From: [Martin Chambers](#)
To: [Mona Offshore Wind Project](#)
Cc: [REDACTED] [@m3wind.com](#); [Laura Leigh](#); [Ellie Dakin](#); [Neil Roberts](#)
Subject: Deadline 7: Tan-y-Mynydd Fishery response to Hypothetical Hydrgeological Risk Assessment Report (HHRA)
Date: 13 January 2025 11:00:37

Mona Wind Farm Project

Feedback on Hypothetical Hydrogeological Risk Assessment (HHRA)

Document Number: MOCNS-J3303-RPS-1042

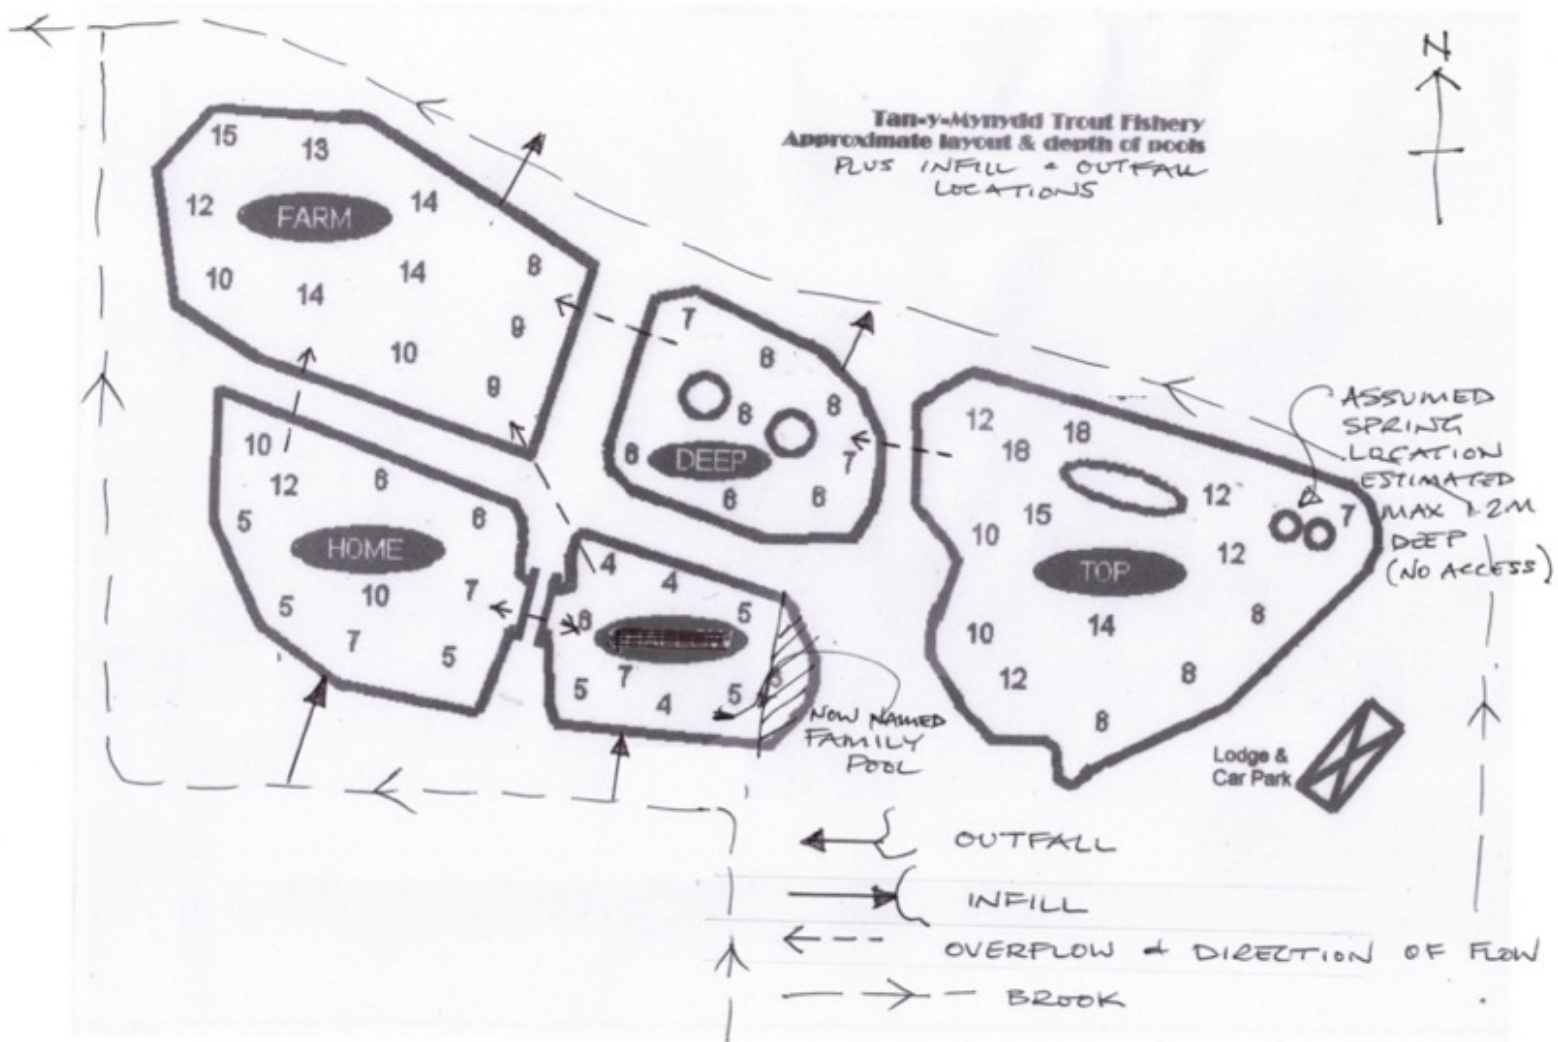
1. Introduction	1	1.2.1.2	Reference is only to a single spring and fails to address the permanent situation	
	2	1.2.1.4	Single spring only referenced	
	2	1.3.1.1	Report lacks any significant quantitative data, therefore any suggested findings are highly subjective. The report constantly refers to a single spring, giving rise to serious concerns over the validity of the findings	
2 Tan-y-Mynydd Trout Fishery	3	2.1.1.2	Elevation relates solely to difference between Top lake surface level and proposed cable corridor. This fails to recognise the elevation of western spring at the point where it emerges above ground	
	4	2.2.1.3	Suggested spring discharge point of 7m below water surface level on Top Pool is incorrect, more likely 1.2m max. There is no manhole access into 'wells' on Top Pool and water flow routes are incorrect.	See attached sketch with correct flow routes
	4	2.2.1.4	Assertions on internal water distribution are generally incorrect	See attached sketch with correct flow routes

Figure 8: Schematic groundwater recharge catchment area, showing the Onshore Cable Corridor and the Tan-y-Mynydd Trout Fishery

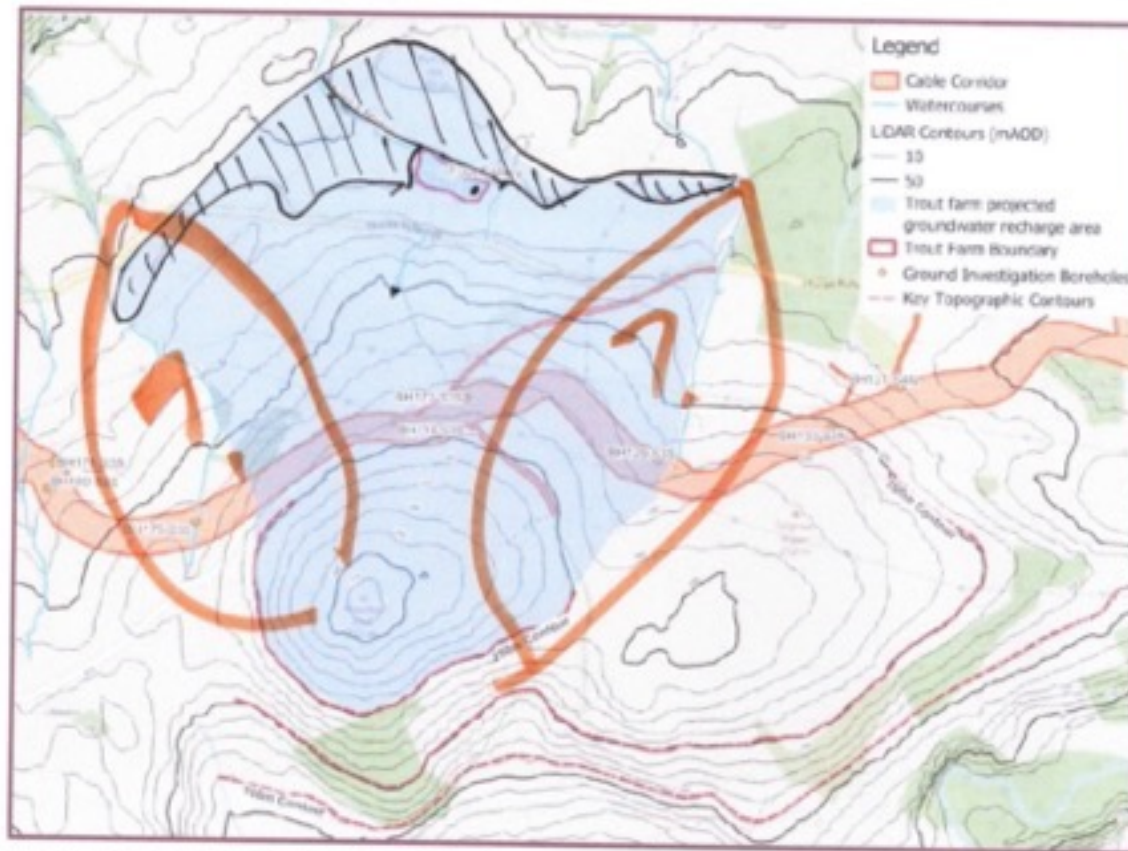
Section	Page	Para	Observations / Comments	Note
3. Site Setting	21	3.4.3.2	We consider that Figure 8 is highly optimistic in its representation of the potential extent of the recharge catchment area. The area to the north of the fishery has previously been discussed and discounted. However, in addition the areas of land to the east and west of the highlighted indicative catchment area do appear more likely to serve the other water courses shown as adjacent to them and not those springs serving the fishery. We therefore consider that the highlighted area (shaded in blue within Figure 8) to be some 60% larger than might reasonably be expected to actually serve the fishery.	See attached marked up figure 8
	23	3.5.1.3	The 70m vertical separation again fails to recognise the elevation at which the spring serving the brook on the south boundary of the fishery emerges above ground.	
	24	5.5.1.4	Figure 10 is highly biased in the way that it purports to indicate the extent of the possible location of the 'highly fractured sandstone unit in the Elwy Formation (ground water bearing)'. There is no evidence provided to indicate why this formation is considered not extend to the route of the cable corridor.	See attached marked up figure 10

3	21	3.4.3.2	<p>We consider that Figure 8 is highly optimistic in its representation of the potential extent of the recharge catchment area. The area to the north of the fishery has previously been discussed and discounted. However, the areas to the east and west of the highlighted indicative catchment area do appear more likely to serve the other water courses shown as adjacent to them and not those springs serving the fishery. We therefore consider that the highlighted area (shaded in blue within Figure 8) to be some 60% larger than might reasonably be expected to actually serve the fishery.</p> <p>For clarity, we would suggest that even the reduced catchment area we offered in our feedback is actually supporting a minimum of 2 if not 3 springs. 1 spring directly feeds Top Pool, a second spring appears to feed the brook that emerges in the South East corner of the fishery lands and a third spring emerges higher up the mountain and then feeds the brook which runs North until it intersects with the fishery's Southern boundary and then turns West. This brook feeds Family, Home and</p>	<p>We agree that the catchment area as presented is schematic, nor are we saying this entire catchment area IS contributing to flow at the spring at Top Pool. Rather, it highlights a 'total area' that could potentially support the spring at the TYM fishery based on simplifying assumptions most notably shallow flow and topography. However, it is known that flow paths in fractured aquifers do not necessarily follow topography and can be oblique thereto.</p> <p>It is also noted that the observations summarised in table 4 and presented in Hydrogeological Conceptual Model 2 suggest the highly fractured shallow bedrock aquifer that may supporting the spring appears in the eastern section of the cable corridor. The catchment area would therefore extend further eastward than shown, toward the unconfined area around second peak at Talgrwn Mawr immediately east of Moelfre Isaf.</p>

Figure 10: Conceptual Hydrogeological Model 2 – highly fractured sandstone or mudstone units in the Elwy Formation

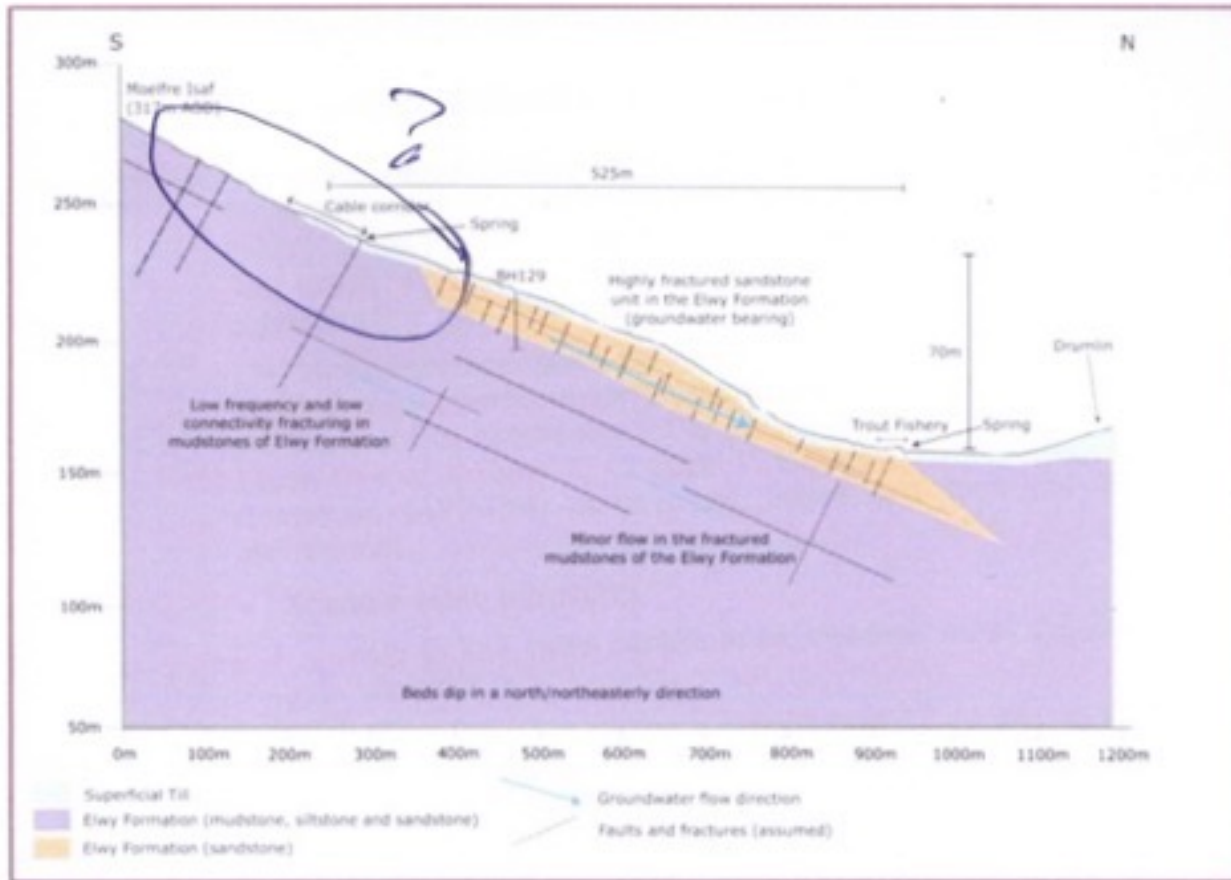
ultimately Farm pools.	
3	24	3.5.1.4	<p>Figure 10 is highly biased in the way that it purports to indicate the possible location of the 'highly fractured sandstone unit in the Elwy Formation (ground water bearing)'. There is no evidence provided to indicate why this formation does not extend to the route of the cable corridor.</p> <p>I think we are agreeing with each other, in that there is no borehole evidence to confirm whether the fractured sandstone stops below the proposed cable corridor or extends through it. If our use of the term 'bias' offends we apologise. That said, we do not believe there is currently any evidence to support the work produced and detailed in the HRA.</p>	<p>We do not agree with the assertion of bias given that the risk assessment presented in Appendix D and summarised in section 4 does consider the shallow highly fractured sandstone aquifer extending up to the cable route corridor in the east (as seen in the eastern logs / photographs). This extent of the unit shown in Figure 10 simply reflects the fact this cross section was produced early on in the development of the HRA.</p>
